CAPITOL POWER PLANT

Architect of the
Capitol Should
Update Its Long-term
Energy Plan before
Committing to Major
Energy Projects

September 3, 2015

Figure 6: Proposed Cogeneration System Using a Combustion Turbine

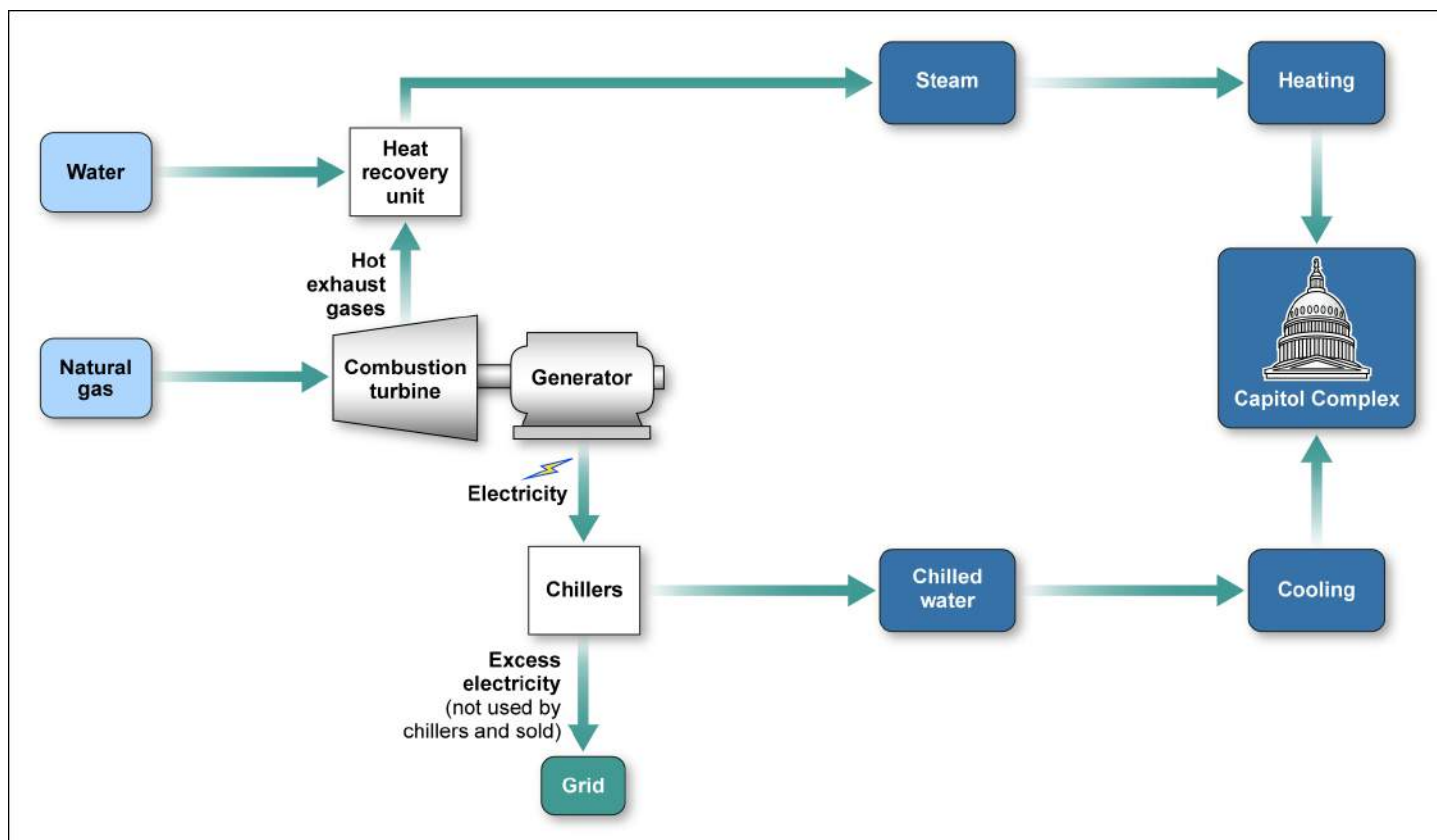
AOC officials stated the cogeneration system, despite initial costs that are significantly higher than other alternatives, will provide needed steam and save money over time by producing electricity to power its chillers—thereby avoiding or decreasing the costs of purchasing electricity. In addition, cogeneration systems can produce excess electricity that can be sold to local utilities, thereby generating income that helps offset the cost of the system.

generate steam by fiscal year 2016.²⁸ To address this projected gap in capacity, the 2009 plan assessed nearly 30 capital alternatives for installing new steam-generating equipment, including natural-gas-powered boilers, a cogeneration system, or nuclear capabilities. The 2009 plan evaluated the capital alternatives using several criteria, including total life cycle costs, initial construction costs, air pollution emissions, energy efficiency, and security.^{29,30} AOC's 2009 plan recommended that AOC continue to operate CPP as a district energy system to provide heating, and in that context, the best options based on life cycle costs and environmental impacts would involve a new cogeneration system or the use of synthetic coal.³¹ Ultimately, citing concerns about the cost and availability of synthetic coal as well as environmental concerns, the plan recommended that AOC procure a cogeneration system.³²

Specifically, the 2009 long-term plan recommended that AOC purchase a cogeneration system comprising one 7.5-megawatt cogeneration combustion turbine, which would represent the first of a three-phase plan.³³ The 2009 plan also called for the installation (in two subsequent phases) of five natural gas boilers along with two other combustion turbines—another 7.5-megawatt turbine and a 15-megawatt turbine—and the equipment needed to distribute electricity throughout the complex.

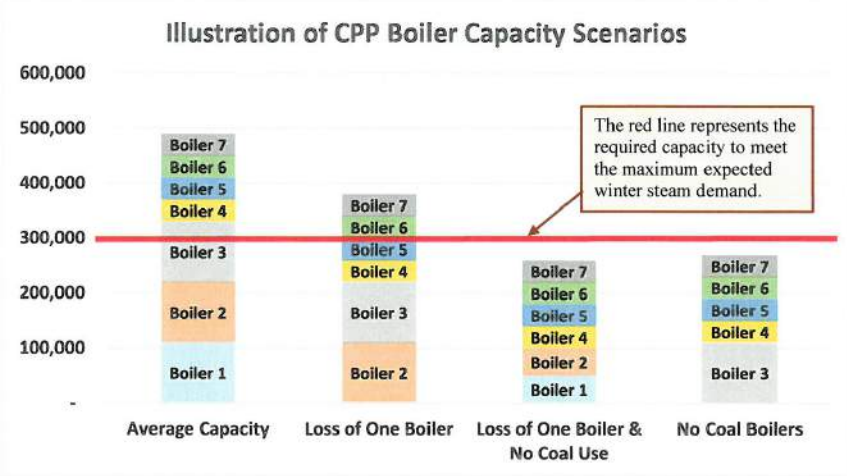
the available capacity of the boilers. This results in a sustainable available capacity of 490,000 pounds of steam per hour.

See comment 2

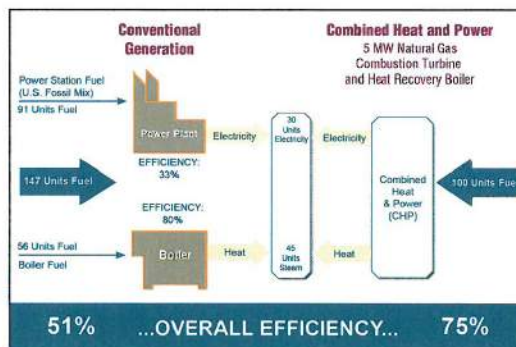
NREL's conclusions also noted that "the selection of the Combined Heat and Power (CHP) option is a better option than a new 100,000 pound per hour gas boiler for a number of reasons."

The NREL-produced graphic (at right) illustrates the difference in efficiencies between Cogeneration and a gas boiler for a typical system, such as the one the CPP would be installing.
